**Martin Lake D Area
Lignite Surface Mine
Henderson, Rusk County
Texas**

FINAL ENVIRONMENTAL IMPACT STATEMENT
MARTIN LAKE "D" AREA LIGNITE SURFACE MINE PROJECT

RESPONSIBLE AGENCY: U.S. Environmental Protection Agency, Region 6

PROPOSED ACTION: Issuance of new source National Pollutant Discharge Elimination System (NPDES) permit to Texas Utilities Generating Company (TUGCO) for discharge of wastewater from the Martin Lake "D" area lignite surface mine near Henderson, in Rusk County, Texas.

FIG. I-1
PROJECT LOCATION MAP

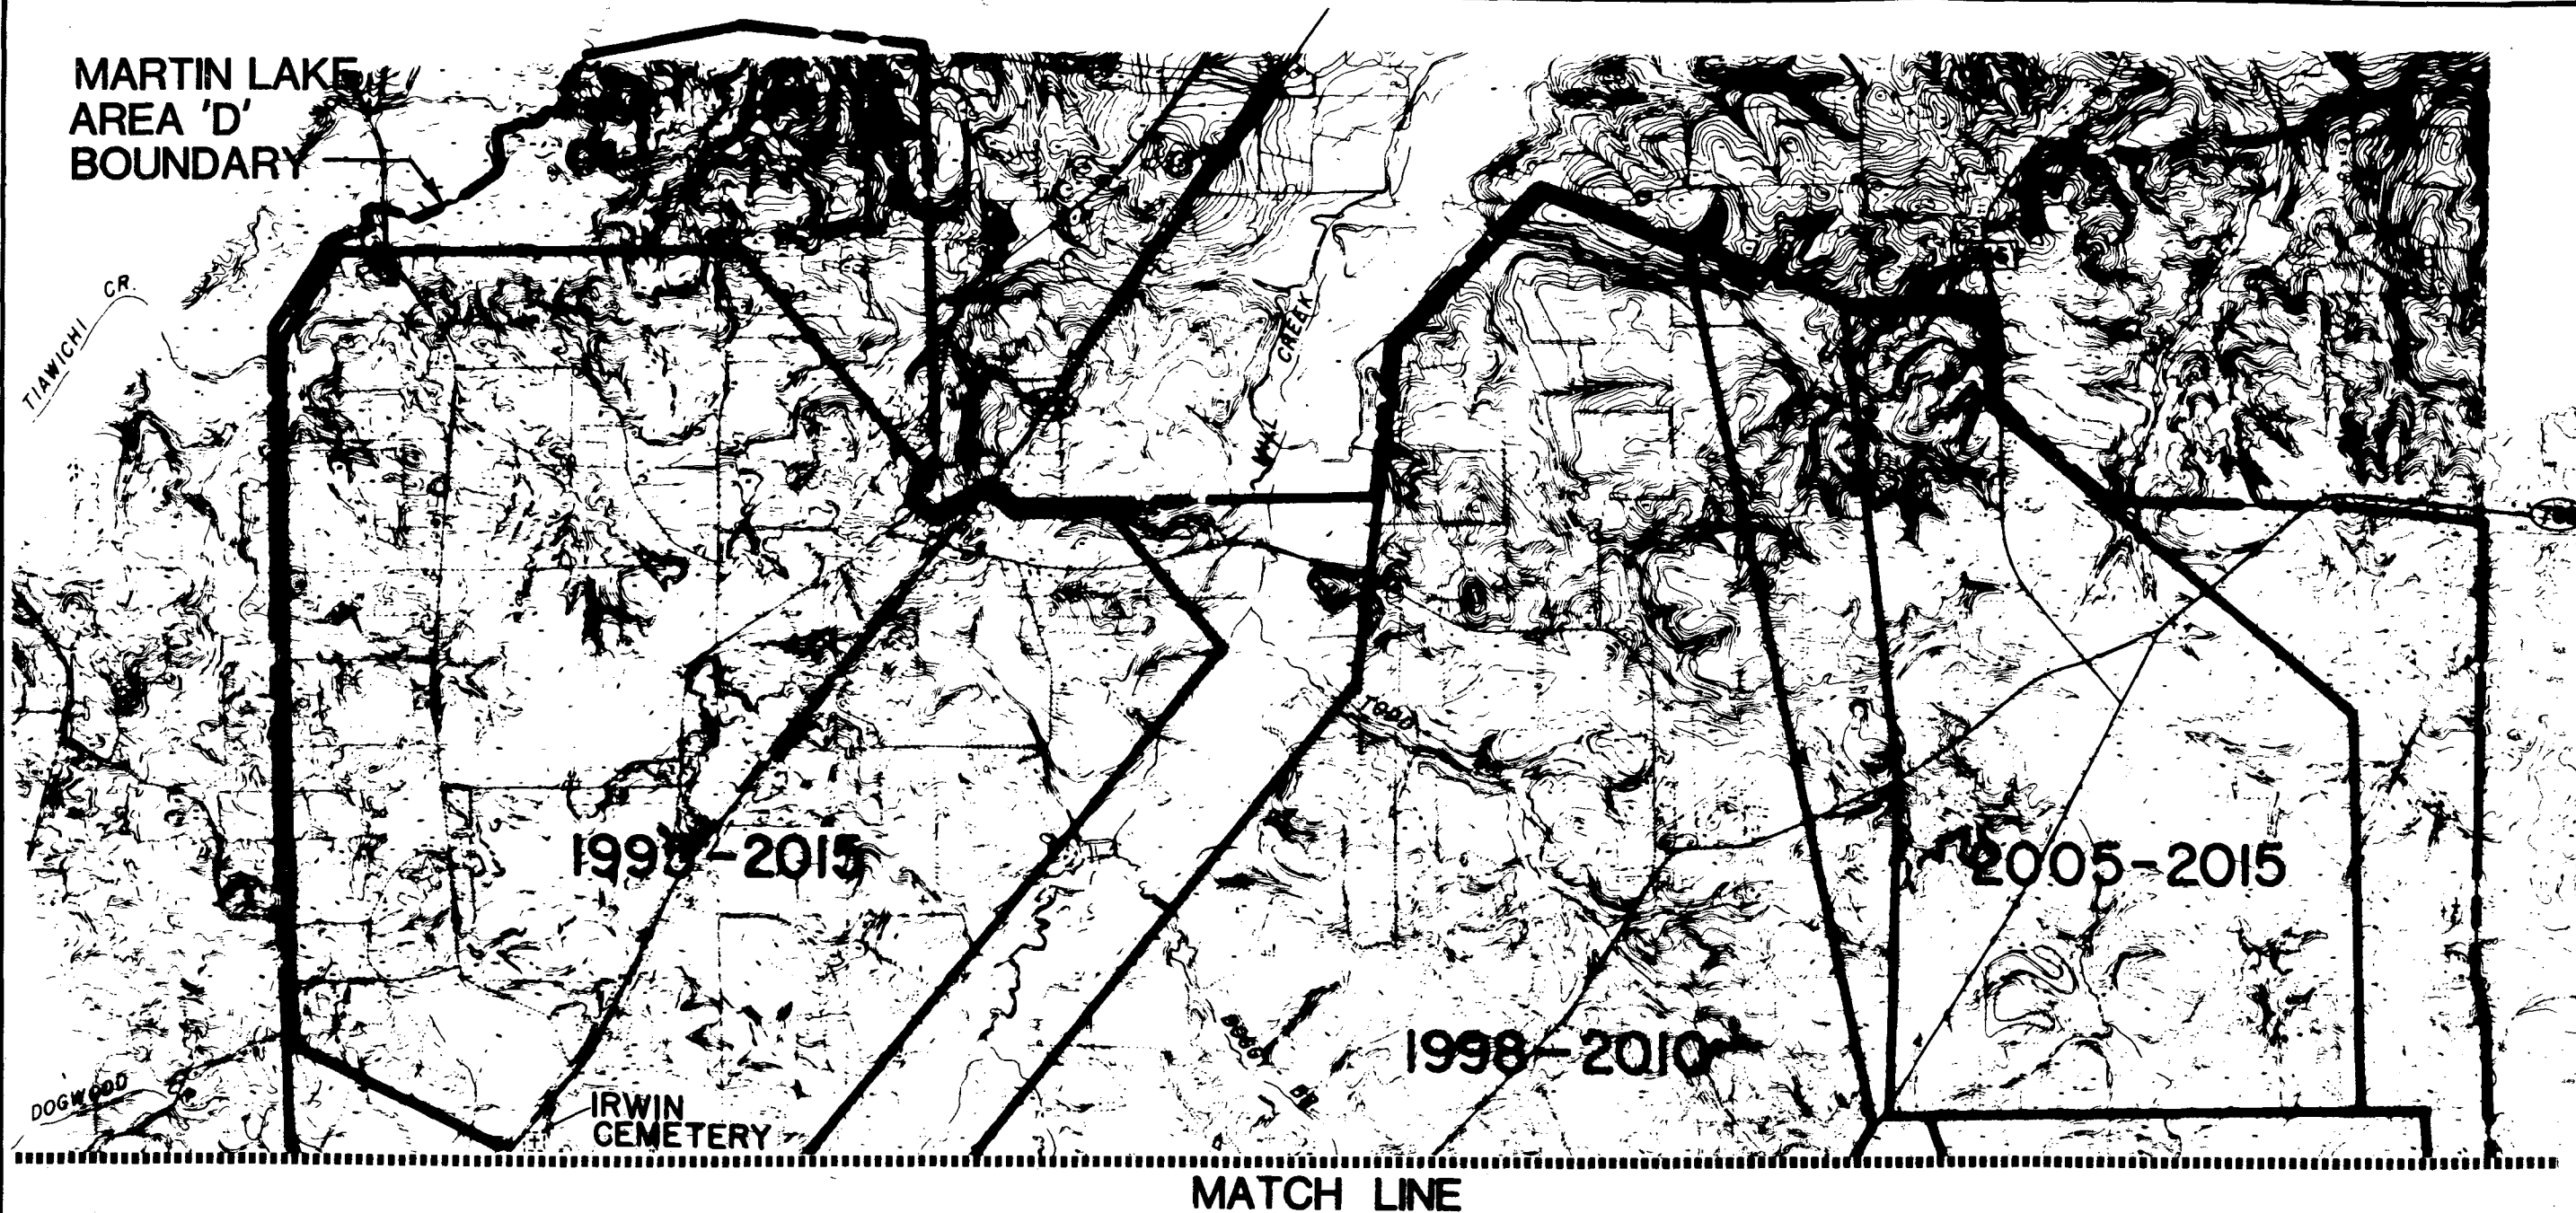
Page 5-17, paragraph 5: The figure showing the general sequence of mine blocks should be correctly identified as Fig. I-2. The figure is included in this document as Fig. I-1.

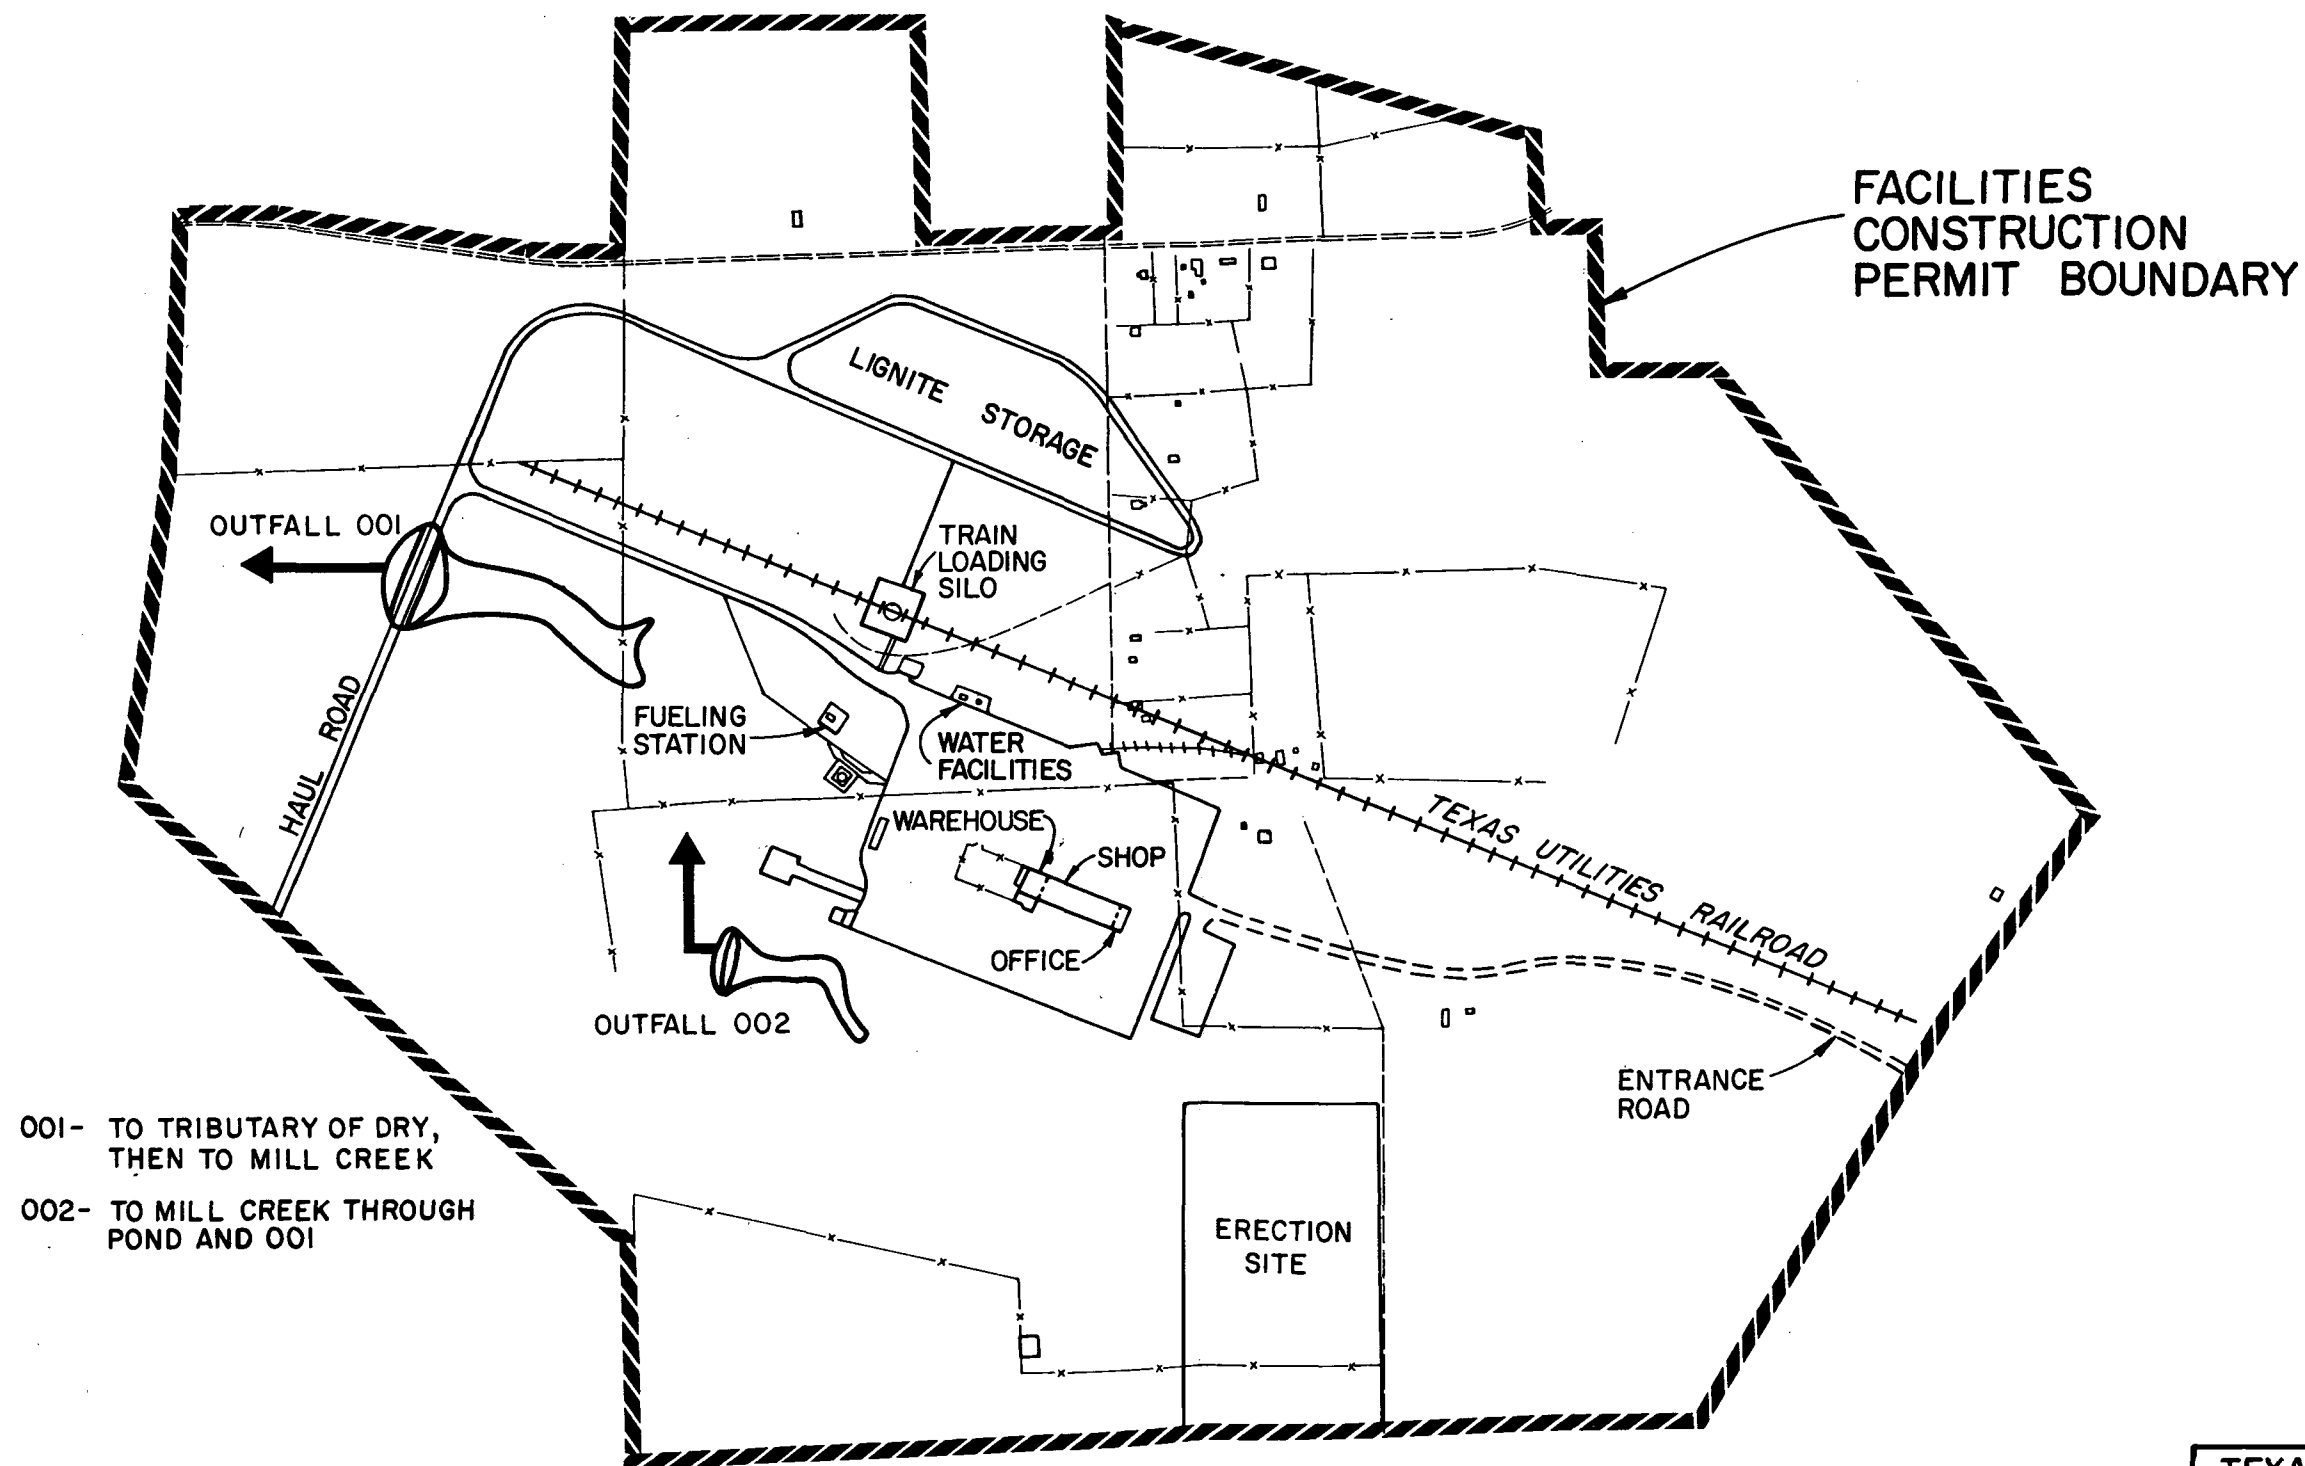
On-site sanitary waste control is proposed by package sewage treatment plant to secondary treatment level with effluent discharge to Dry Creek (see Fig. III-1). Mining water pollution control is proposed by collection and settling in sedimentation ponds. Polyelectrolyte would be utilized for lignite fines removal; pH control would be by lime addition. Discharges to streams are proposed based on new source alkaline mine drainage category standards for coal mining.

The mine facilities area (Fig. III-1) (office, shop, train loading station, dragline erection pad, etc.) would preempt about 210 acres composed of pastureland (126 acres); upland pine/hardwood and regenerative forest (55 acres); pine plantations (21 acres); and cropland (8 acres).

FIG. III- 3
PROJECTS CONSIDERED IN
CUMULATIVE IMPACT ANALYSIS

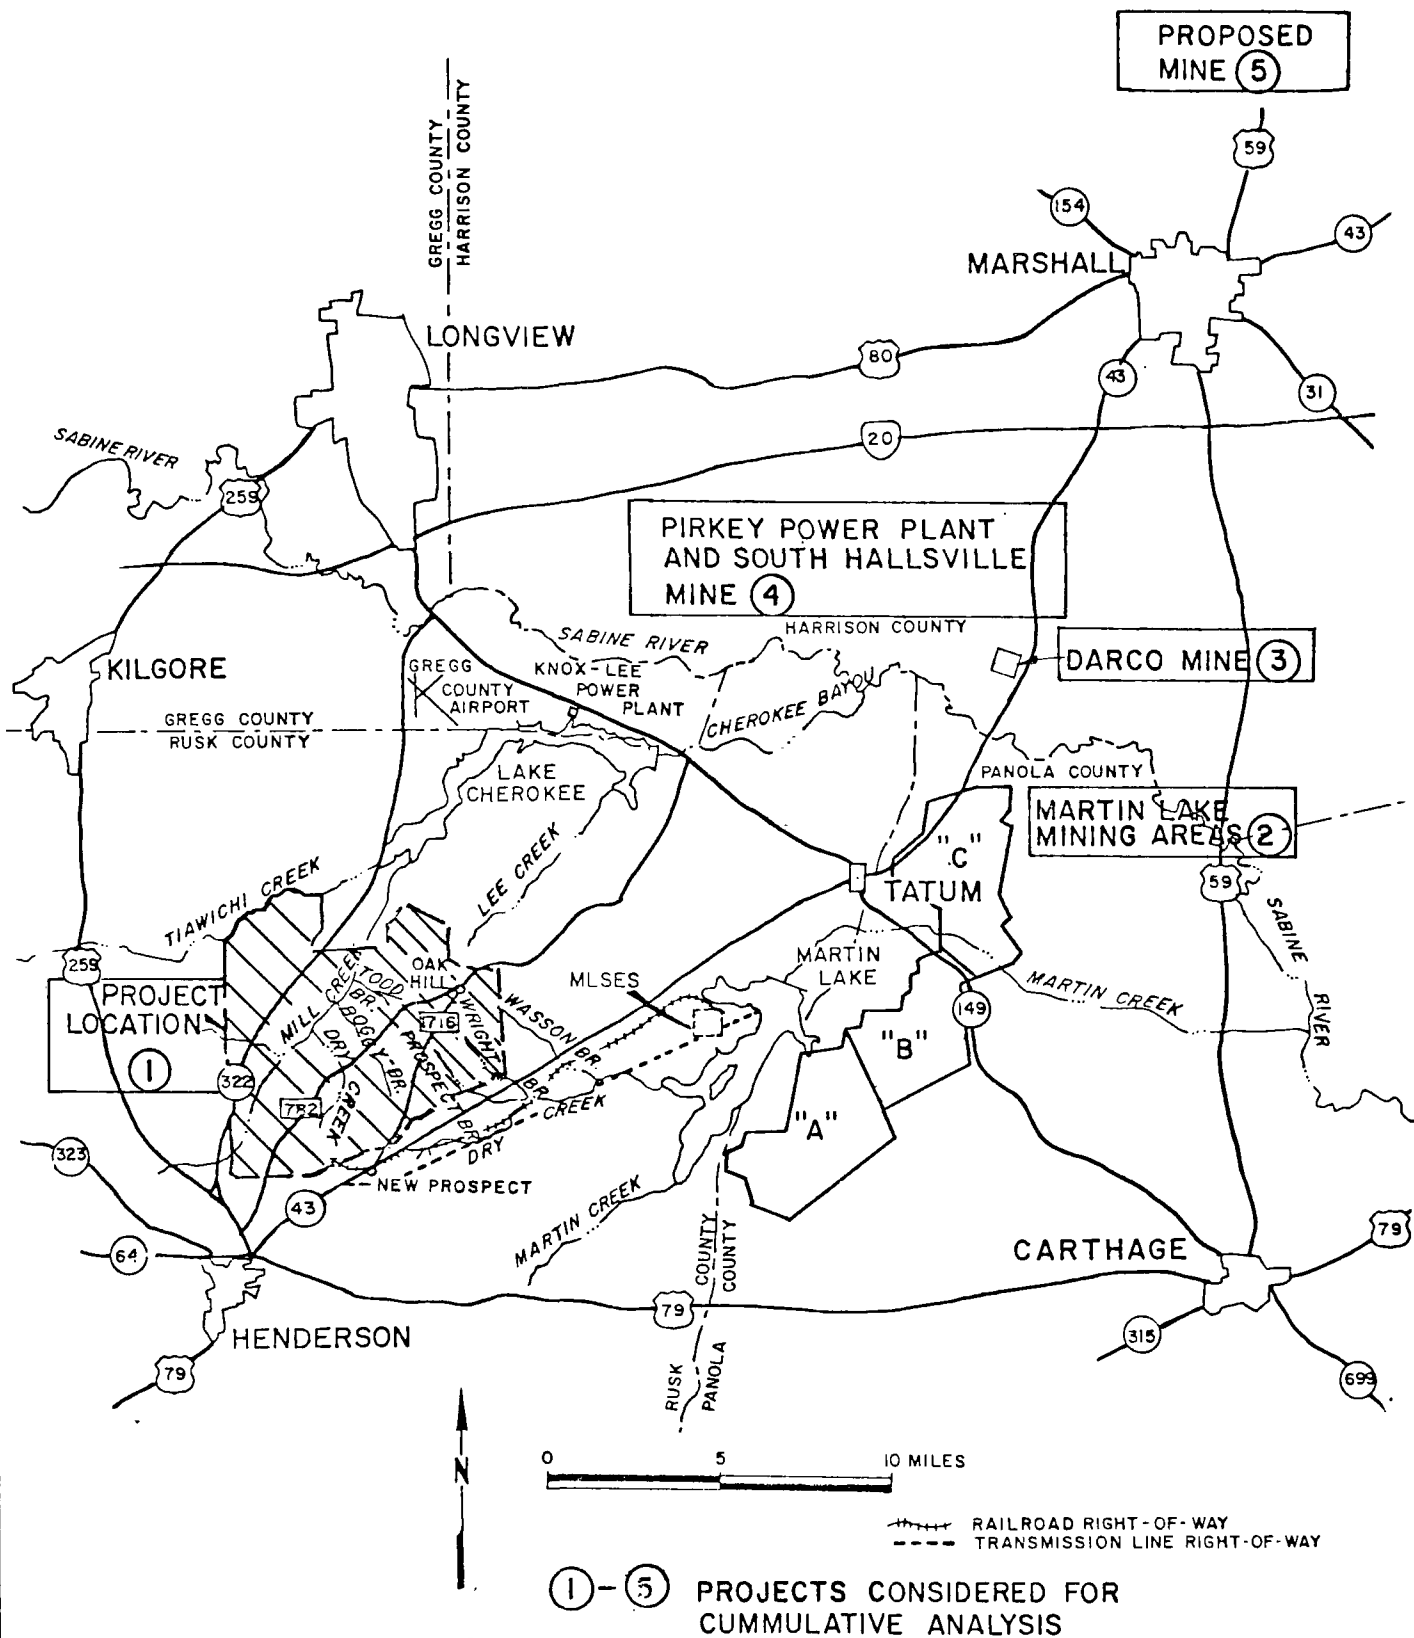
3. An explanation is needed as to why "materials" comprise nearly one-third of the annual operation and maintenance cost shown on page 6-144.
4. Section 6.15.3.1 refers to four other mine and/or power plant projects in the region during the same time period yet there is not even a brief narrative on these projects. A tabulation of employment, population impacts, residential impacts, school attendance, etc. would be helpful in assessing the cumulative impacts of these projects.

Figure III-3 shows the general location of the eight projects considered during the cumulative impacts analysis. Figure III-4 shows a more detailed relationship of four of those projects to the "D" area.
